ADDENDUM NO. 1 TO PROJECT NO. 45384

CONSTRUCTION WORK, HVAC WORK, PLUMBING WORK, ELECTRIC WORK

VARIOUS SECURITY IMPROVEMENTS
BUILDING NO. 62
HUDSON CORRECTIONAL FACILITY
EAST COURT STREET,
HUDSON, N.Y.

January 6, 2016

DRAWING NUMBER: **E-202**

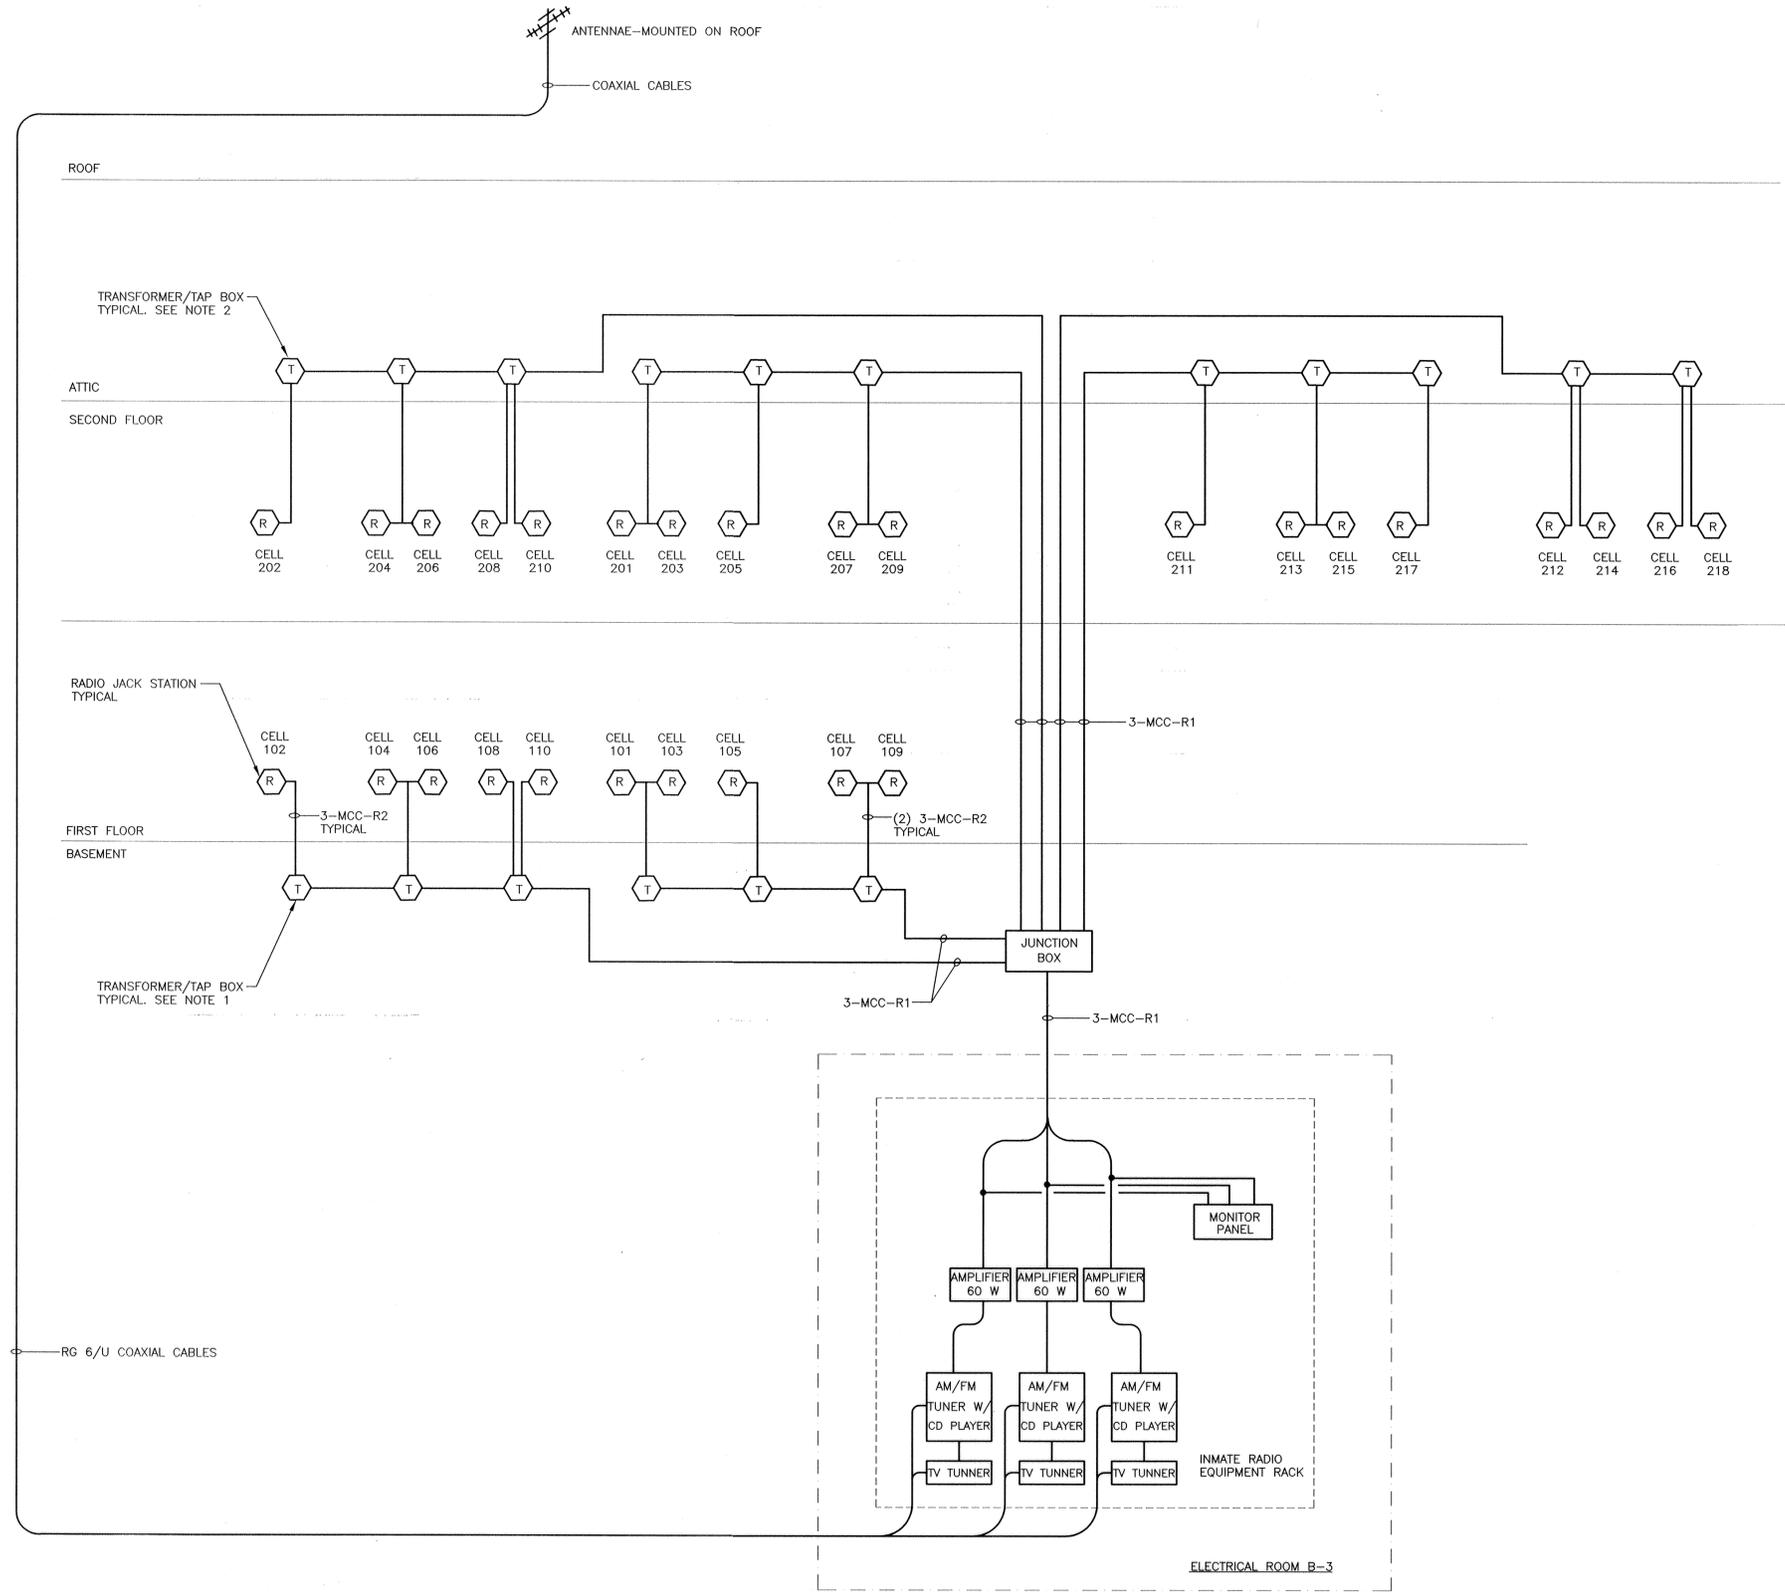
1. LOCATE TRANSFORMER/TAP BOX ON CEILING OF BASEMENT. INSTALL 3-MCC-R2 CONDUCTORS (PER CELL) IN RIGID METAL CONDUIT UP FROM BASEMENT TRANSFORMER/TAP BOX TO INMATE RADIO STATION LOCATED ON THE FIRST FLOOR.
2. LOCATE TRANSFORMER/TAP BOX ON FLOOR LEVEL OF ATTIC. INSTALL 3-MCC-R2 CONDUCTORS (PER CELL) IN RIGID METAL CONDUIT DOWN FROM ATTIC TRANSFORMER/TAP BOX TO INMATE RADIO STATION LOCATED ON THE SECOND FLOOR.

DRAWING NUMBER:
E-203

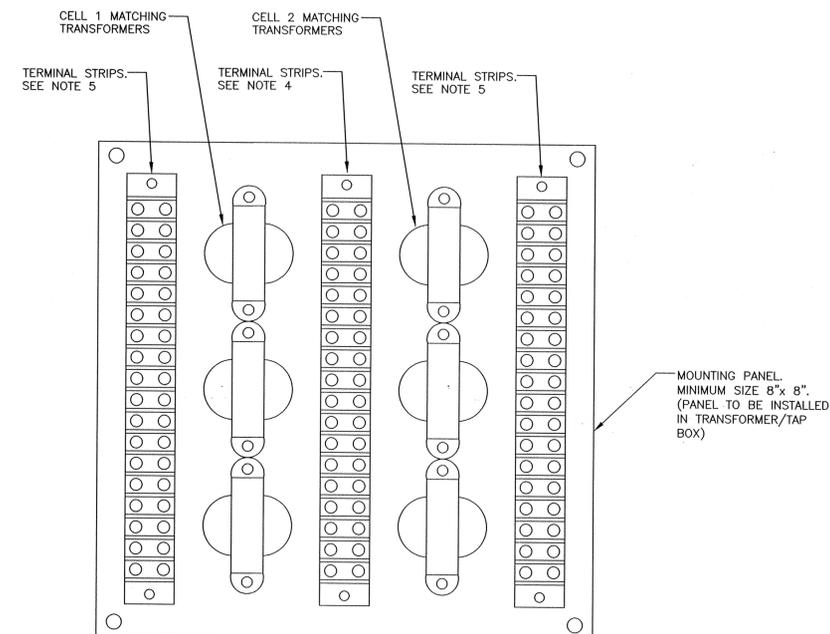
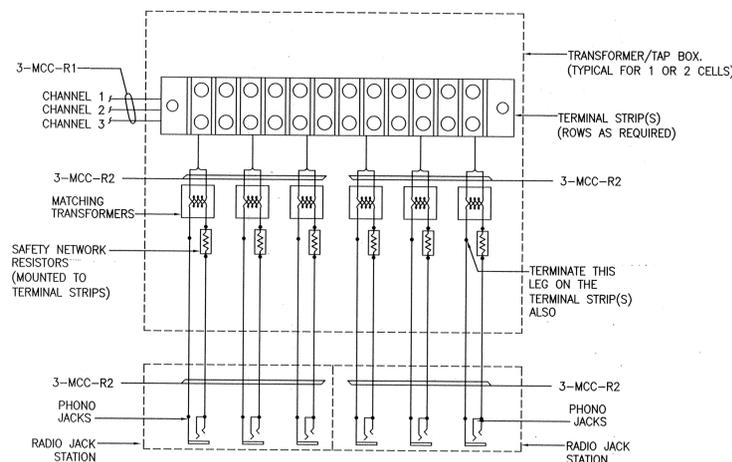
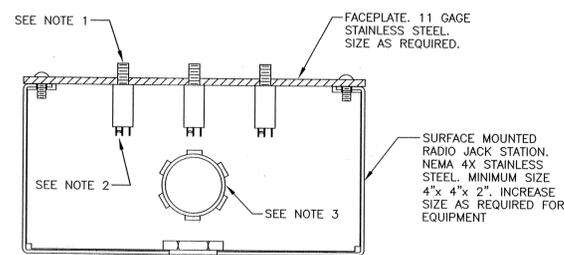
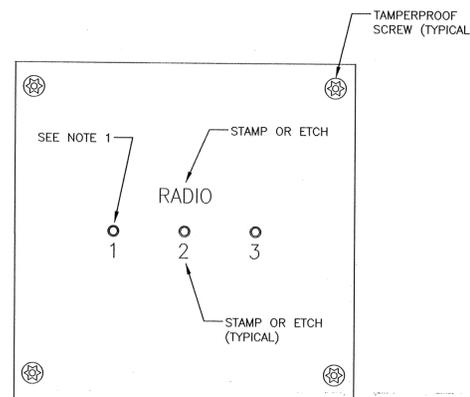
1. PROVIDE 1/8" HEADPHONE JACKS. DRILL AND TAP THE FACEPLATE. APPLY LOCTITE TO THE THREADED PORTIONS OF THE JACKS THAT WILL ENGAGE THE TAPPED PLATE.
2. PROVIDE A JUMPER BETWEEN THE TIP AND RING CONNECTION TABS.
3. PROVIDE RIGID METAL CONDUIT FOR ALL CONNECTIONS TO INMATE RADIO JACK STATION, EITHER UP FROM BASEMENT TRANSFORMER/TAP BOX FOR FIRST FLOOR JACK STATION, OR DOWN FROM ATTIC TRANSFORMER/TAP BOX FOR SECOND FLOOR JACK STATION.
4. USE THIS STRIP(S) TO CONNECT THE WIRING INTO AND OUT OF THE CORRIDOR TO. ALSO USE IT TO CONNECT TO THE PRIMARY OF THE TRANSFORMERS. PROVIDE JUMPERS BETWEEN THE TERMINALS AS NECESSARY TO ALLOW FOR ORGANIZED CONNECTIONS.
5. USE THIS STRIP(S) TO MOUNT THE SAFETY RESISTORS, CONNECT TO THE TRANSFORMER SECONDARIES, AND TO THE CABLING GOING TO THE CELL JACKS.
